MISSOULA COUNTY
INVITATION FOR BID ADDENDUM

IFB NAME: Missoula County Detention Facility Cooling System Upgrade
DUE DATE: July 9, 4:00 p.m., Local Time

ADDENDUM NUMBER: 1 **06-2026-03-A**

Addendum No. 01
Date: July 2, 2026
Project: Missoula County Detention Facility, Cooling System Upgrade
Owner: Missoula County
Architect: Cushing Terrell
306 W Railroad Ave, Ste. 104
Missoula, Montana 59802

1 ENLARGED PLANT MECHANICAL PLAN 4
M100 1/4" = 1'-0"

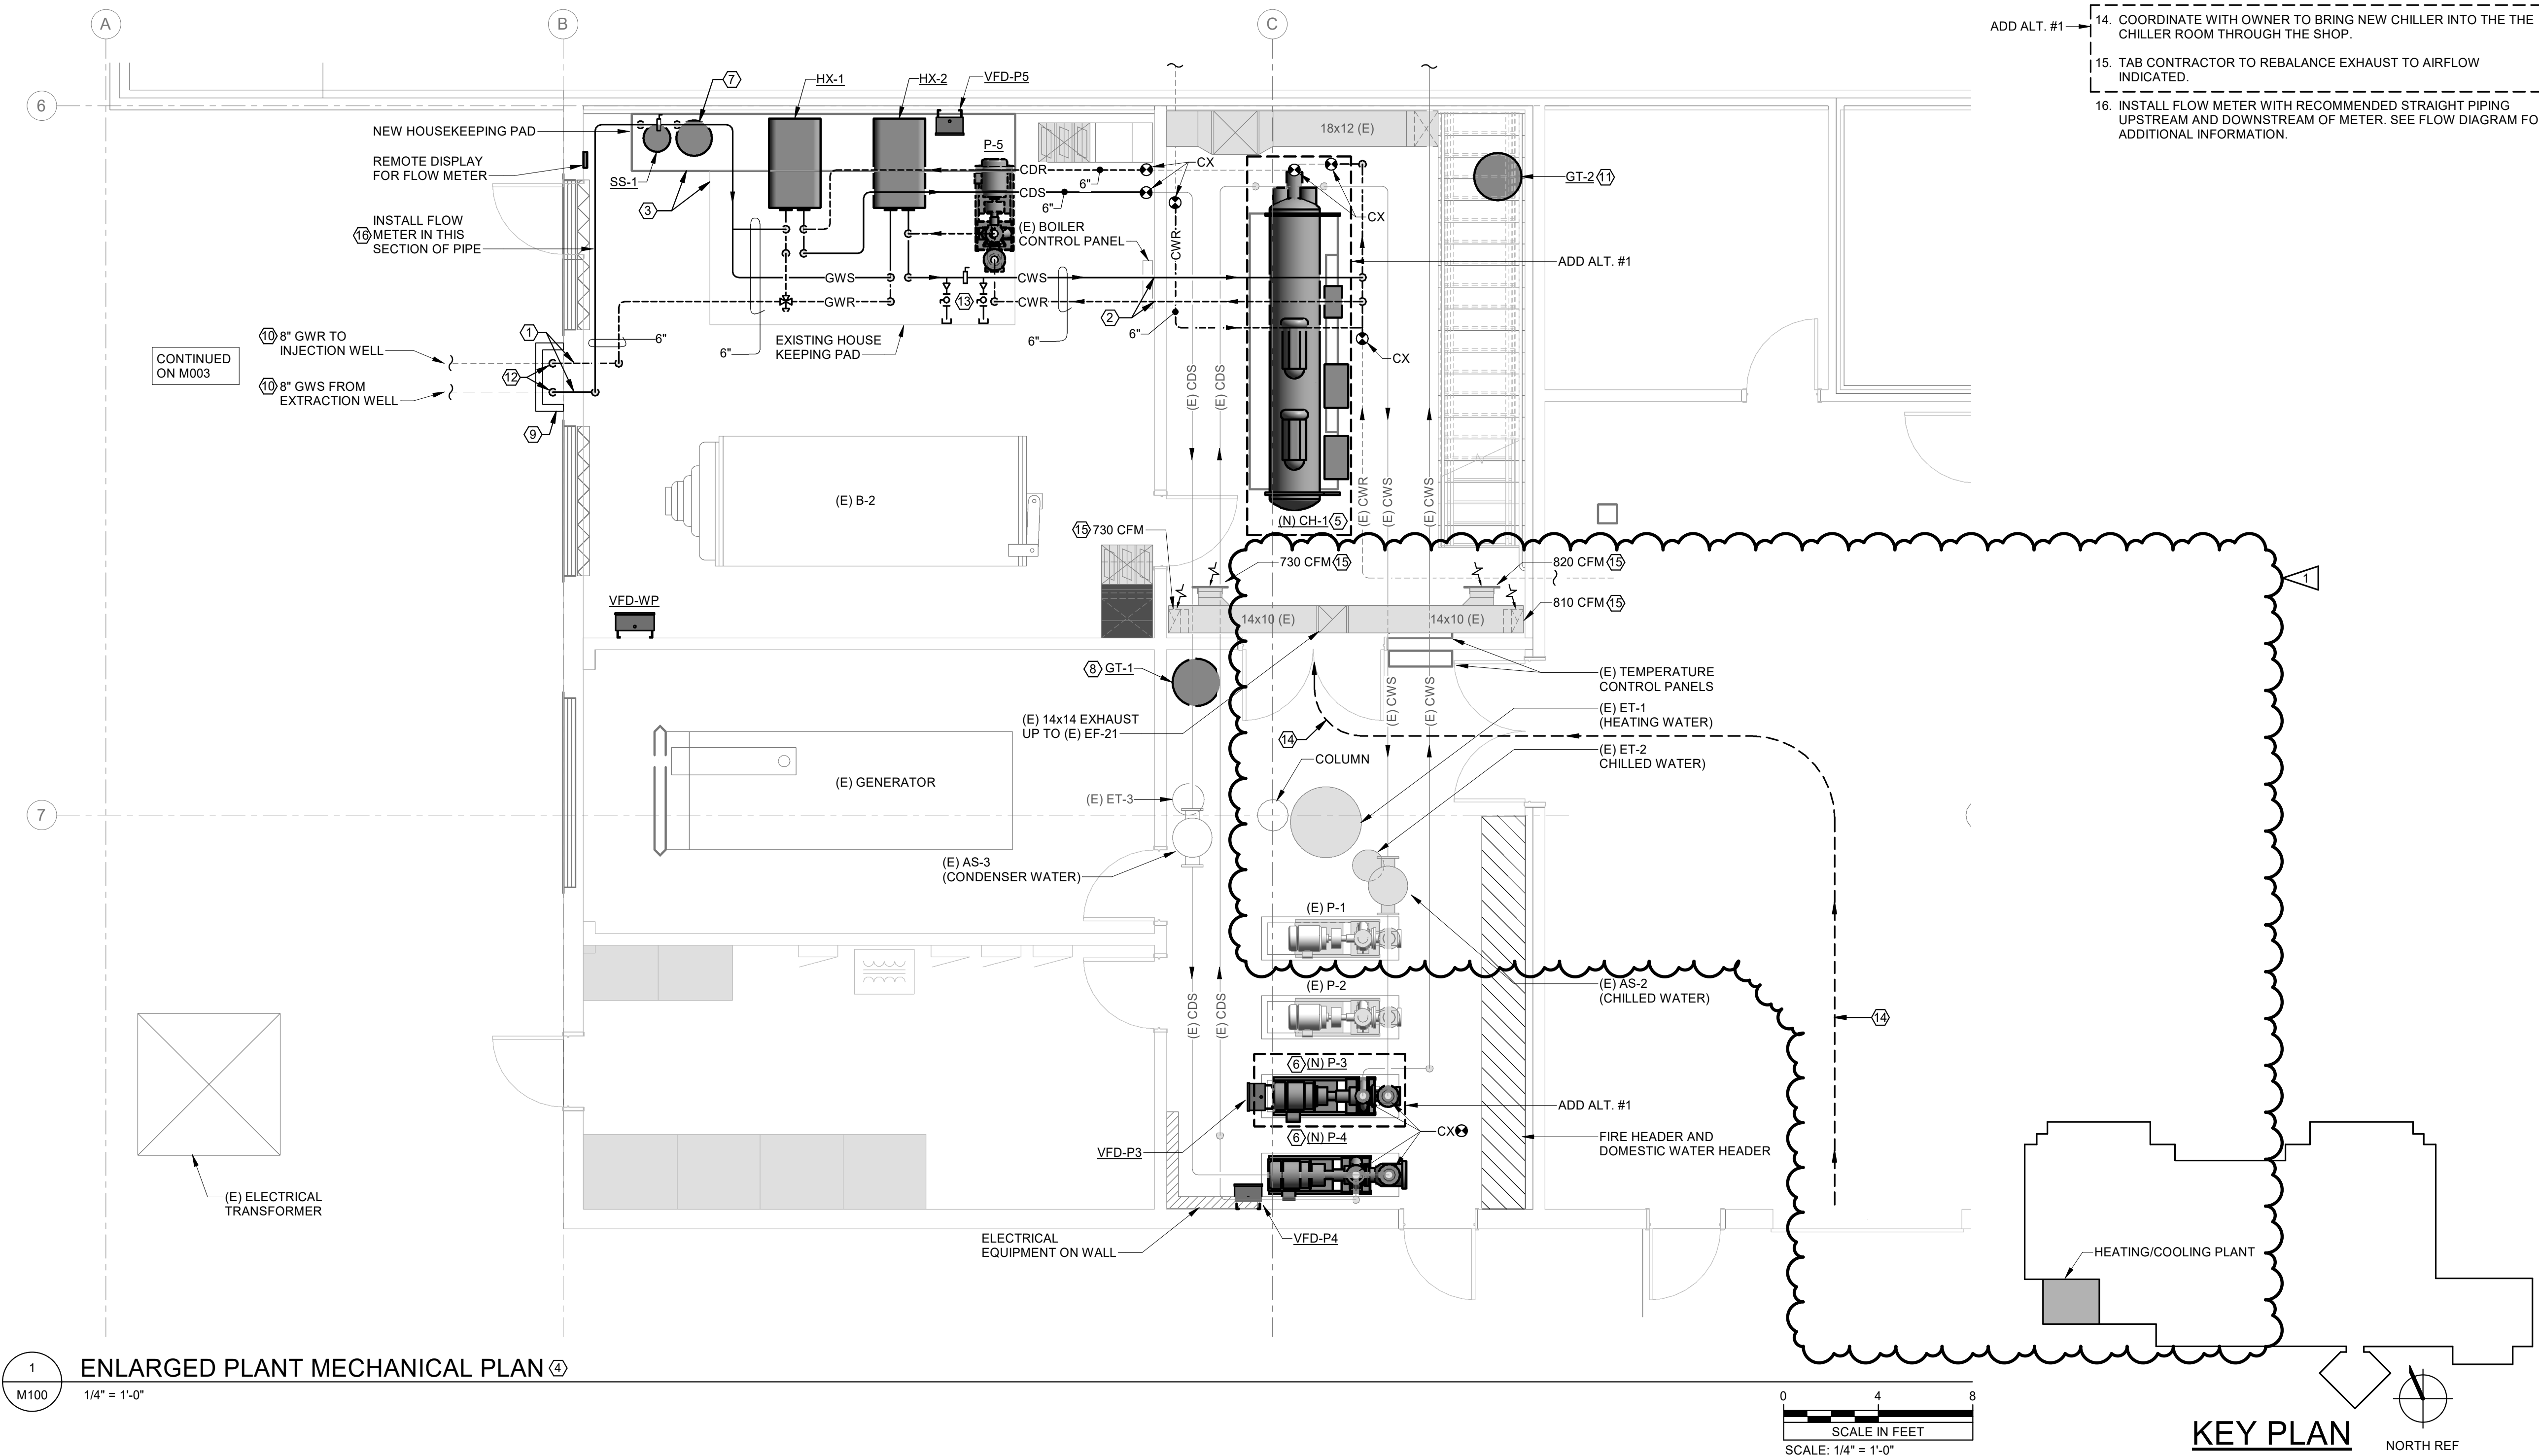
SHEET M100 – ENLARGED PLANT MECHANICAL PLAN (see attached revised drawing)

1. CLARIFY: Path for bringing new chiller into the chiller room.

- 14. COORDINATE WITH OWNER TO BRING NEW CHILLER INTO THE CHILLER ROOM THROUGH THE SHOP.
- 15. TAB CONTRACTOR TO REBALANCE EXHAUST TO AIRFLOW INDICATED.
